PCN – Process Change Notification

Change:	IP.1621.25.4.A.02
Date:	2016/05/25
Author	Haley Tsai

Model#	Part Number	Changes
IP.25A Iridium Patch 25x25x4	IP.1621.25.4.A.02	1. Amend pin height dimension.
		2. Packaging rule changing.

Illustration of Change (IP.1621.25.4.A.02)

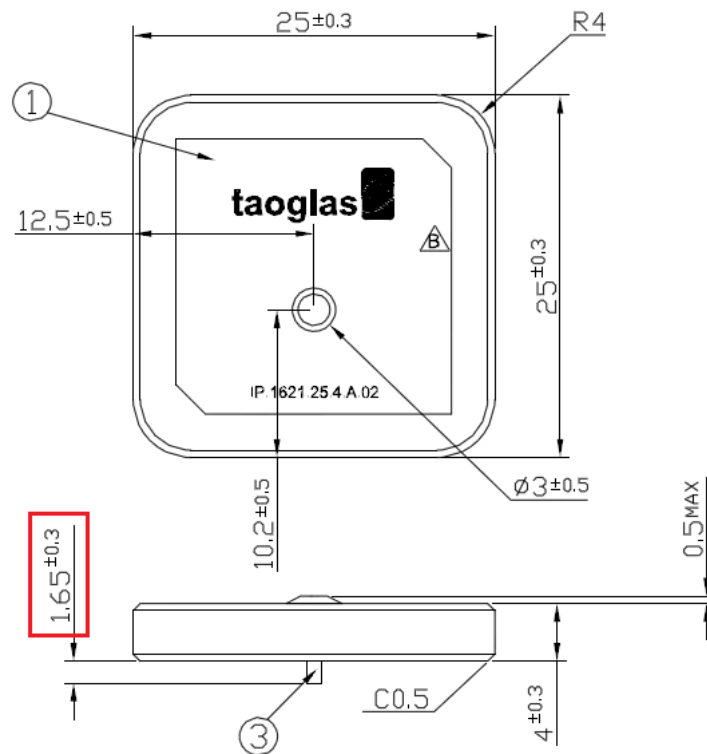
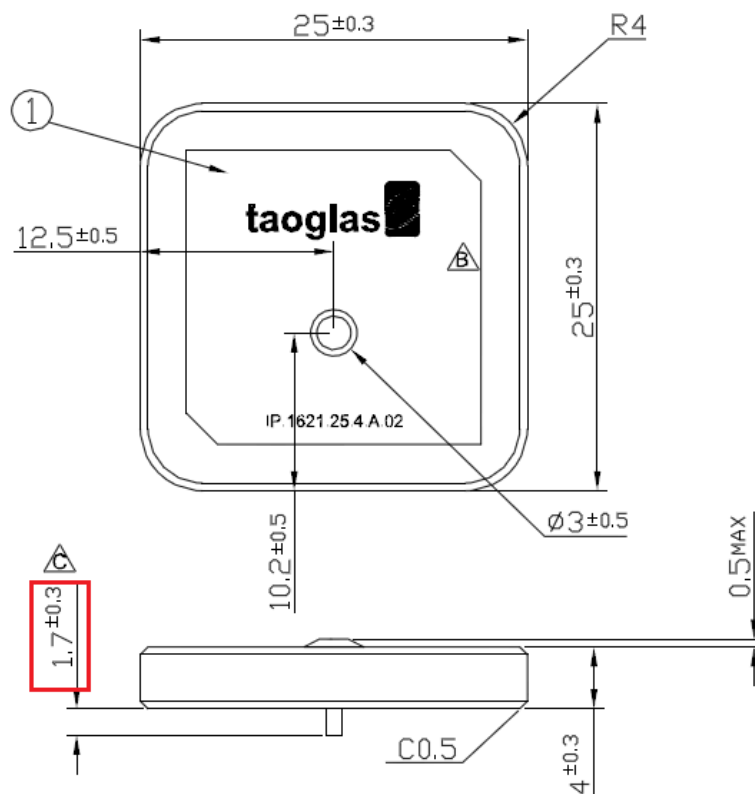
1. Revised pin height dimension from 1.65mm to 1.7mm.
2. Because Taoglas will input Barcode tracking process, we need to amend the packaging rule and affix barcode labels to standard packaging quantity bags and cartons.
